# Mobile Intel® Pentium® 4 Processor-M

Specification Update

*October 2004*

Document Number: 250721-026

**Figure 13. System Bus Reset and Configuration Timings**

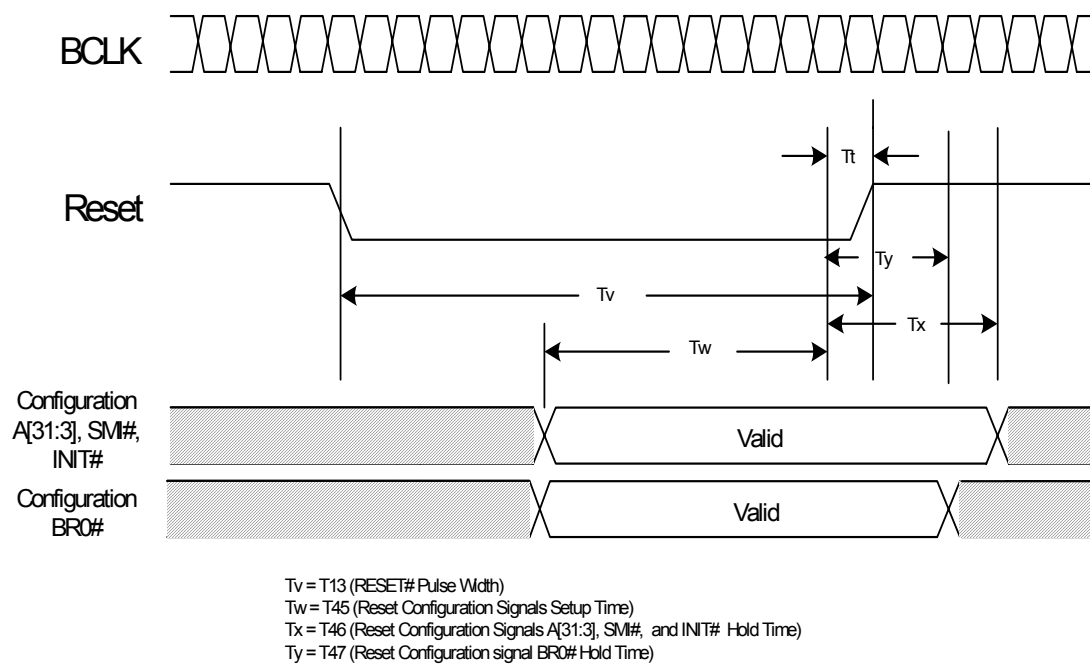
## T2. BR0# Maximum Hold Time Specification Change

The BR0# maximum hold time has changed to 2 BCLKs. This change will be shown in the “System Bus AC Specifications (Reset Conditions)” table and “System Bus Reset and Configuration Timings” figure of the *Mobile Intel® Pentium® 4 Processor - M Datasheet*. This change will be incorporated in the next revision of the datasheet.

The following figure will be modified to reflect this change:

T# Parameter	Min	Max	Unit	Figure	Notes
T45: Reset Configuration Signals (A[31:3]#, BR0# INIT#, SMI#) Setup Time	4		BCLKs	13	1
T46: Reset Configuration Signals (A[31:3]#, INIT#, SMI#) Hold Time	2	20	BCLKs	13	2
T47: Reset Configuration Signal BR0# Hold Time	2	2	BCLKs	13	2

1. Before the deassertion of RESET#.
2. After clock that deasserts RESET#.
